Determination 2010/113

Refusal to issue a code compliance certificate for the re-cladding of a house at 54 Levley Lane, Katikati

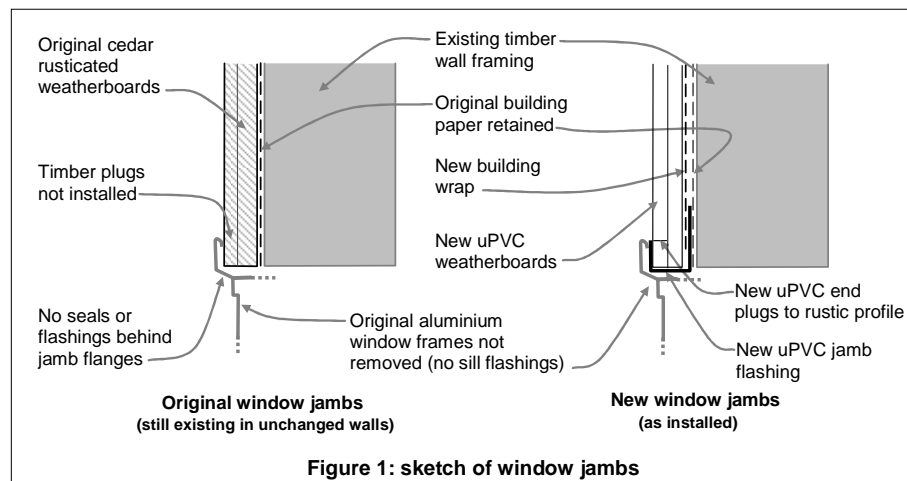
2.5.2 The existing windows within the new weatherboards are therefore face-fixed, with new metal head flashings, uPVC jamb flashings and moulded end plugs to fit the rusticated profile of the boards. The sketch in Figure 1 shows the jamb junctions before and after re-cladding:

- In comparison with the original window junctions, the new junctions provide similar protection to the heads, additional protection to the jambs (see Figure 1) and the same protection at the sills.

- 5.5 Taking account of the above observations and the nature of the re-cladding as alterations, I am satisfied that the new window junctions provide weathertightness and durability at least as good as prior to the re-cladding. I am therefore able to conclude that this building work complies with Clauses E2 and B2.
